DEPARTMENT OF THE ARMY

BUFFALO DISTRICT, CORPS OF ENGINEERS
1776 NIAGARA STREET
BUFFALO, NEW YORK 14207-3199

SUBJECT: NFSS Interim Waste Containment Structure

The information below is provided in response to your letter dated June 23, 2010. We have itemized your concerns so that they could be addressed individually.

Figure 2-3
Site Configuration and Location of Radioactive Contamination
at NFSS in 1981

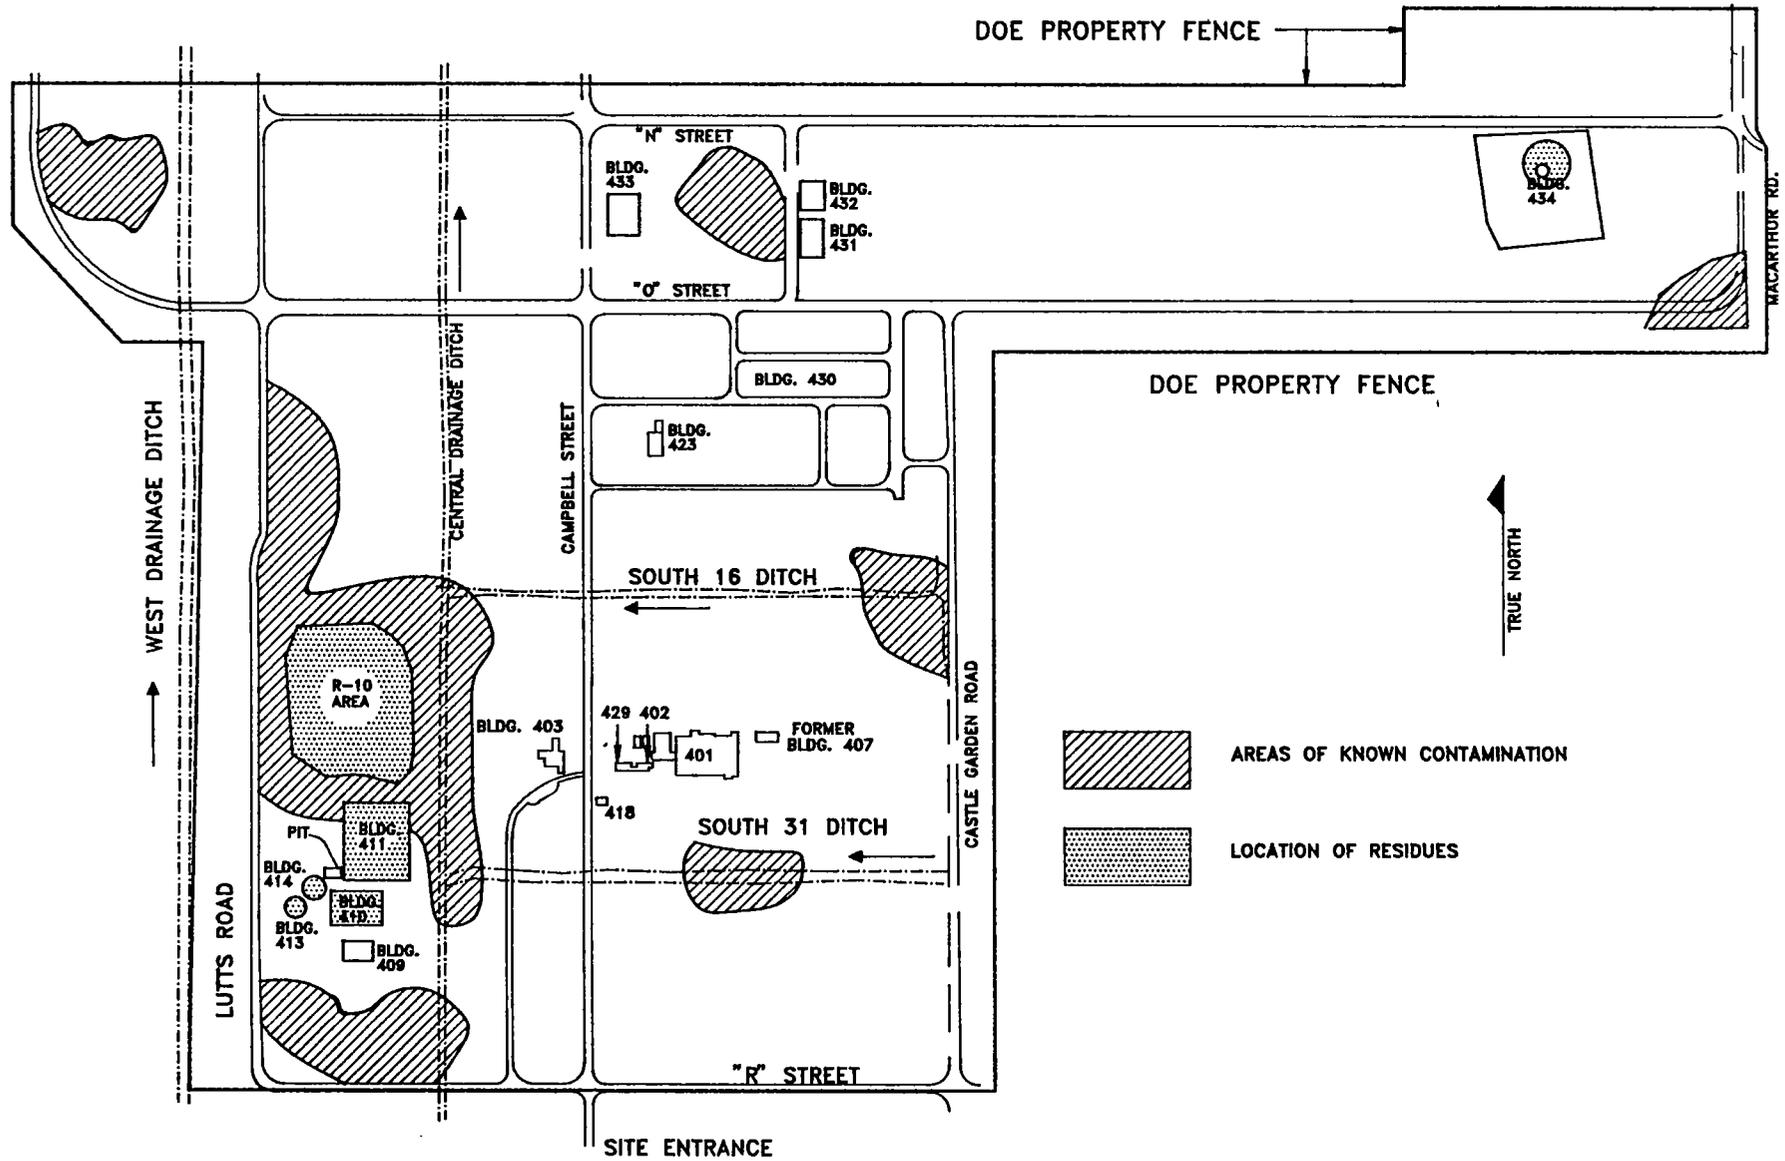
- b. RI and ESP data (contamination in LWBZ west of IWCS in 1993; increased uranium to the south, west, and east of the IWCS) demonstrate that the cell is leaking.

Figure 2-3 in the Chemical Characterization Report prepared by Bechtel National in December 1991 (attached) highlights “areas of known contamination” in 1981, prior to the construction of the cell, which closely resemble total uranium contamination in groundwater measured over 25 years later.
